**RE: Proposed Borings Letter  
76 Service Station No. 6129  
3420 35<sup>th</sup> Avenue  
Oakland, California**

On behalf of ConocoPhillips (COP) Delta Consultants (Delta) is submitting this Proposed Borings Addendum Letter to address current issues at the above referenced site that resulted from our August 13, 2009 onsite meeting. This letter is an addendum to the past planned proposal locations.

Figure 2: Site Plan with Proposed Borings

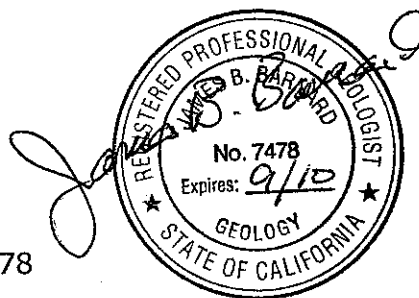
Delta proposes to perform a minimum of five onsite CPT/Geoprobe/Hydropunch borings to at least 50 feet below grade and install two monitoring wells (Figure 2). One proposed boring (B-20) would be placed onsite on the eastern side of the site along Quigley Street, three proposed borings (B-17, B-18, B-19) placed onsite along 35<sup>th</sup> Avenue, and one proposed boring (B-21) along the southwest property line. **Two monitoring wells (MW-4, MW-4A) are proposed to be installed in the vicinity of boring B-21 once the results of the CPT are received and analyzed.**
